**Subject: Response to Administratively Incomplete Determination Part A and General Part B of the Resource Conservation and Recovery Act (RCRA) Permit Renewal Application Los Alamos National Laboratory EPA ID#NM0890010515, HWB-LANL-20-001**

**Response to Administratively Incomplete  
Determination Part A and General Part B of the  
RCRA Permit Renewal Application Los Alamos  
National Laboratory EPA ID#NM0890010515,  
HWB-LANL-20-001**

Below, each numbered NMED-HWB determination is presented verbatim with the Permittees' response following each determination. There are nine attachments to this response document. Attachment 1 includes a crosswalk of the NMED-HWB Determinations and the location of the Permittees' response as well as a summary of the changes for ease in review. Attachment 2 includes maps of groundwater contamination plumes at LANL. Attachment 3 includes seismic information to demonstrate compliance with facility locations standards for each of the three proposed permitted unit locations. Attachment 4 consists of a redline version of the Permit Renewal Application text for Sections 1-7 including a new certification page signed by all Permittees in Section 8. Attachme

Figure 2-3. Wind Roses (day and night averaged for the 365 days of 2018)

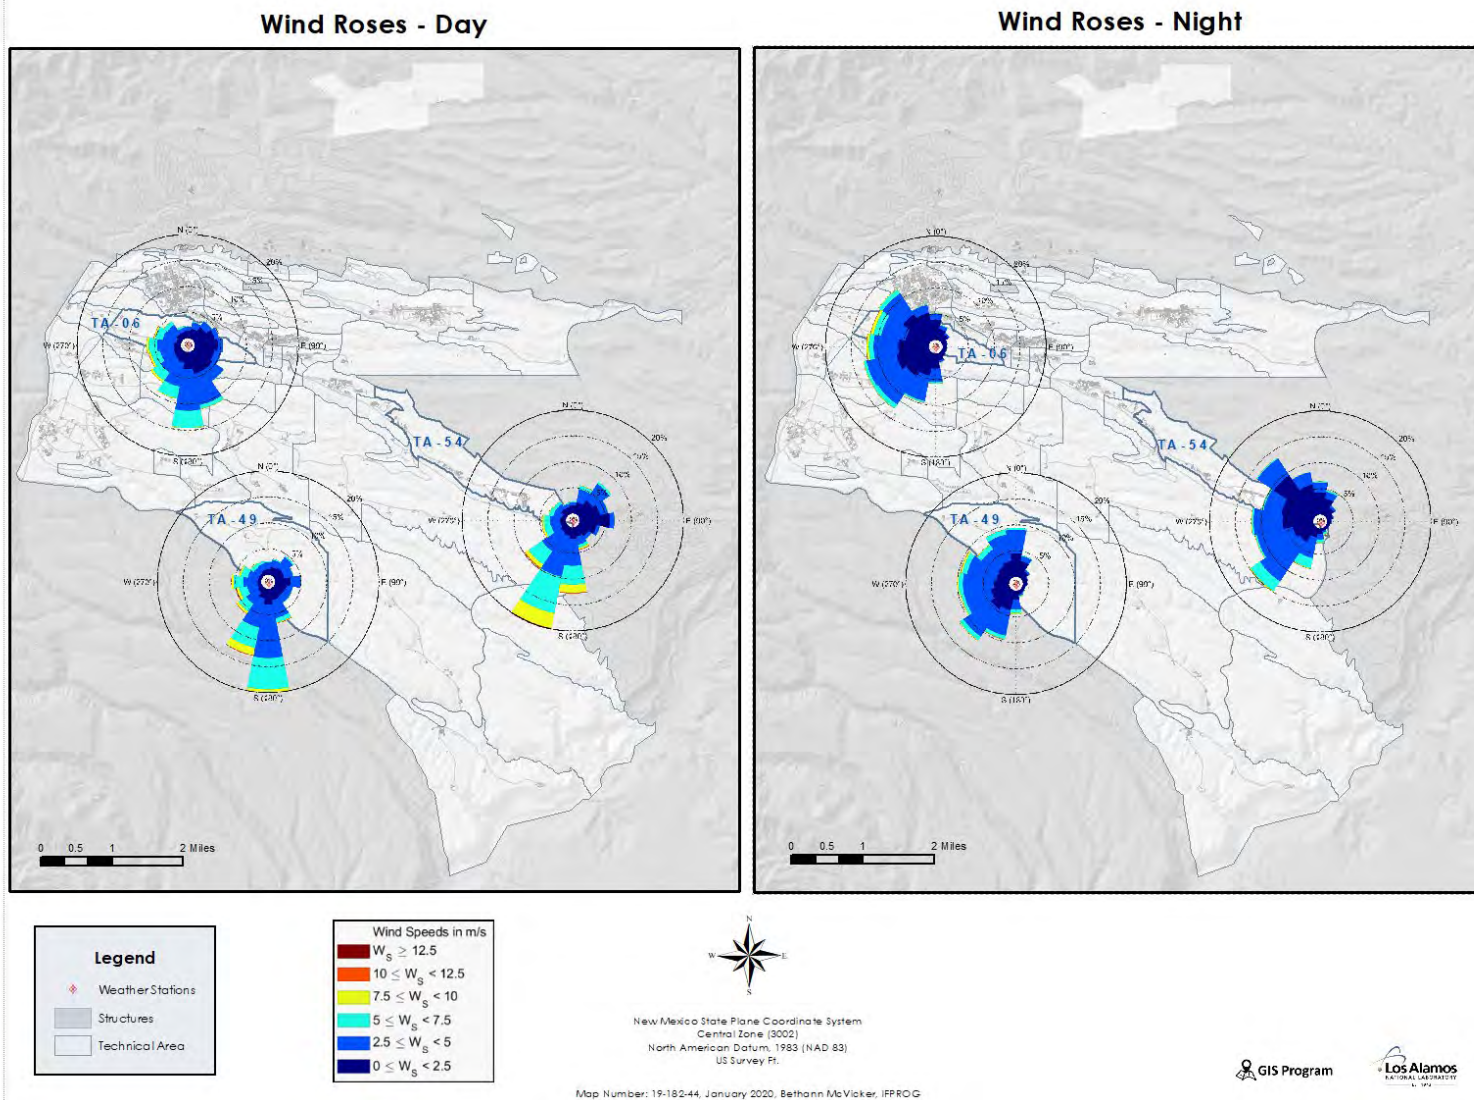
**7. Section 2, Figure 2-3 Wind Roses (Day and Night), page 2-24:**

The Permittees have not provided adequate information regarding the wind roses referenced in Sections 4, 5, and Supplements 4-3 through 4-9, -12, and -13. It is unclear when the data used to generate these wind roses was collected, and how many total days of data are compiled in the figure (e.g., a single year of data, or the average of five years of data). The Permittees must revise this Application to provide additional details on what year or years are represented by the day and night wind roses. Wind roses appear to have been calculated based on data from meteorological stations distant from the proposed OB/OD units. Please provide a rationale explaining why these monitoring locations are

Permit Renewal Application Figure 2-3 is revised (in Attachment 4) to include the year and total days that the wind roses were based upon. These wind roses were drafted based on winds from all 365 days of 2018. In general, wind roses from different years are almost identical in terms of the distribution of wind directions, indicating that wind patterns are constant when averaged over a year. As detailed in the Los Alamos Climatology 2016 Update (<http://permalink.lanl.gov/object/tr?what=info:lanl-repo/eprr/ESHID-602502>), there are four meteorology towers on the mesa tops at LANL at TA-6, TA-49, TA-53, and TA-54. The TA-53 location was not included in the Permit Renewal Application figures because it was deemed to be too far from any of the hazardous waste management units within the Permit or units in interim status. The other three meteorology towers are included in the Permit Renewal Application because they are the closest towers to the permitted and interim status hazardous waste management units. The distance for the TA-6 tower to the interim status units is: TA-36-8, ~4.26 miles; TA-39-6, ~5.5 miles; and TA-16-388, ~1.4 miles. The distance from the TA-49 tower to the interim status units is: TA-36-8, ~1.13 miles; TA-39-6, ~2 miles; and TA-16-388, ~3 miles. For completeness and comparison, the day and night 5-year averaged wind roses for 2016 through 2020 are included as Attachment 5 of this response. The 5-year wind rose data further illustrate that the wind rose information for each of the towers demonstrate very little difference with the exception of the 2018 wind roses that show slightly more intense winds over the single year average compared to the 5-year average.
